Public Hearing: Review of Vista Ridge Permit for Adjusted Well Locations

Re: Application Information – AVR Request to Modify Permitted Well Locations

Example Check on Well Spacing: Simsboro

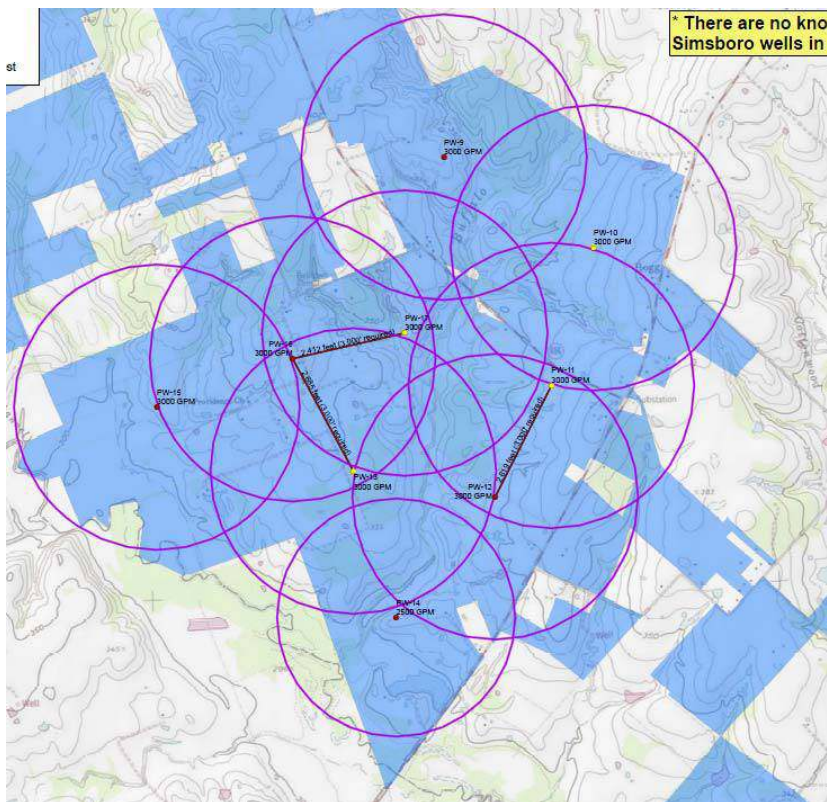
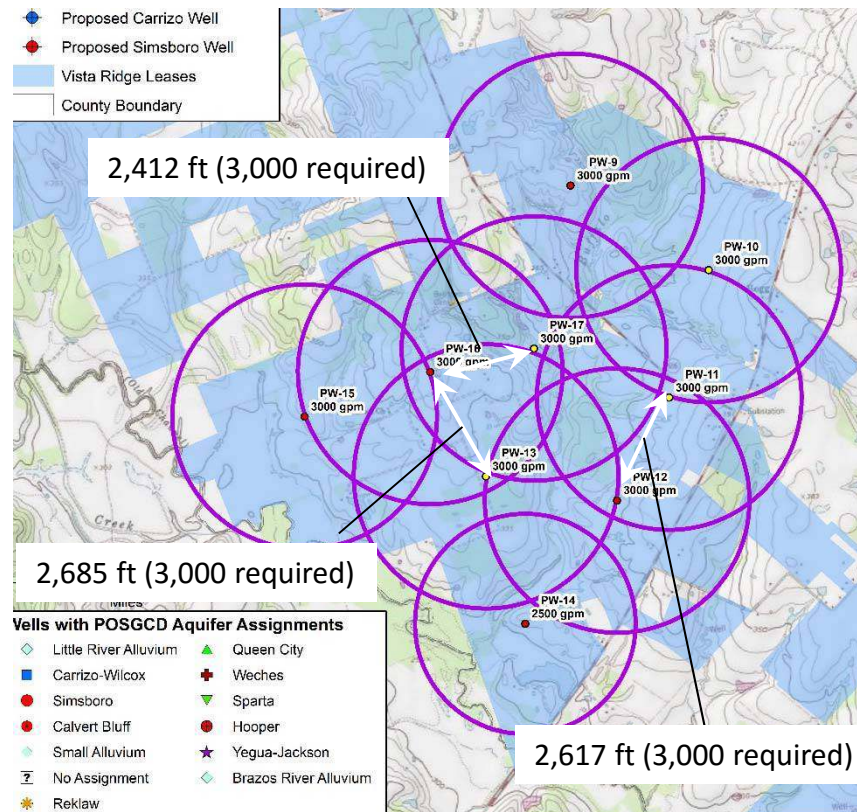
- Confirmed that well spacing and property spacing are accurately presented in application with a minor exception:
 - Revised location of CW-3 is not plotted per submitted coordinates (minor adjustment required in figure)
- Adjusted well locations are in the same model grid cell as the old well locations
- Confirmed that six adjusted Carrizo well locations and five adjusted Simsboro well locations satisfy well and property spacing with three exceptions that occur within leased property
 - Spacing between PW-16 & PW-13 should be 3,000 ft but is 2,685 ft
 - Spacing between PW-16 & PW-17 should be 3,000 ft but is 2,412 ft
 - Spacing between PW-12 & PW-11 should be 3,000 ft but is 2,617 ft

- Recommend that Board grant variance to well spacing requirements for three Simsboro wells and limit the variance to the life of the Vista Ridge Project. Granting the variance will not increase the risk of adverse impacts to operation of existing wells or to district achieving their DFCs.
- If above variance is granted , the application meets all POSGCD permit spacing requirements. Recommend that POSGCD approve the permit.
